**Bid Bulletin #03**

PROJECT: Gateway Early Childhood Center  
Bid Package #4  
Omaha, NE

ADDENDUM F

Gateway Early Childhood Center  
Omaha, Nebraska  
RDG Project No. 2014.129.00, File 35.1

# ELEV. COORIDOR 146 (NORTH)

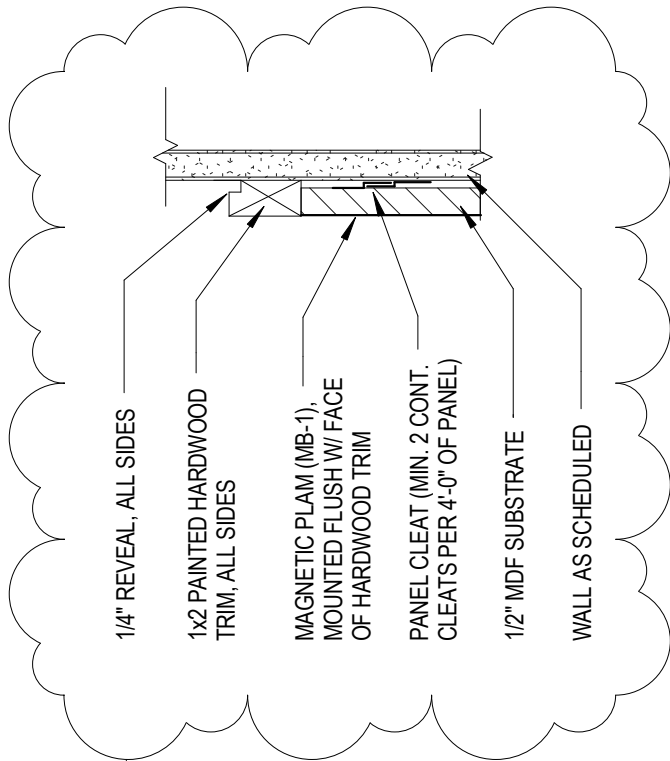
FGD-2 Sheet A13.01 – Interior Elevations and Details, Interior Elevation “B2” - Elev. Corridor 146 (North): Add magnetic board millwork as indicated on attached Supplemental Drawing SDA-025.

(8) HARDWOOD SPINNERS ADHERED TO 3X3 LAZY SUSAN BEARING ON MDF PANEL FASTENED TO GYP BD WALL

WOODEN SPINNERS PLACED SIM. TO LAYOUT

MAGENTIC BOARD (MB-1) ADHERED TO 1/2\"/>

# E1 MILLWORK SECTION

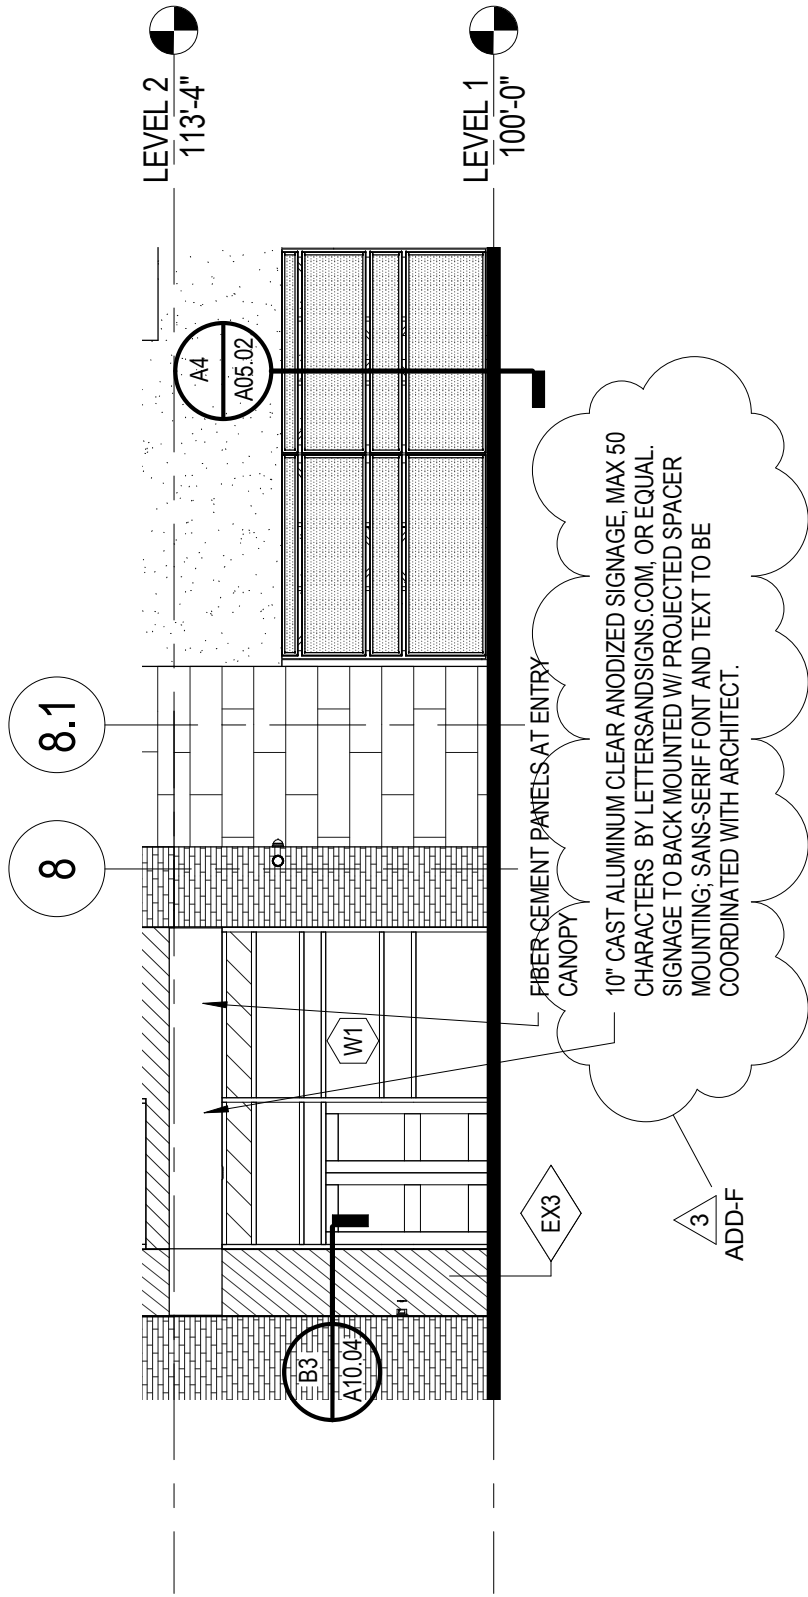
FGD-3 Sheet A13.03 – Millwork Details: Add Detail “E1” – Millwork Section as indicated on attached Supplemental Drawing SDA-026.

1/4" REVEAL, ALL SIDES

1x2 PAINTED HARDWOOD TRIM, ALL SIDES

MAGNETIC PLAM (MB-1), MOUNTED FLUSH W/ FACE OF HARDWOOD TRIM

PANEL CLEAT (MIN. 2 CONT. CLEATS PER 4'-0" OF PANEL)

1/2" MDF SUBSTRATE

WALL AS SCHEDULED
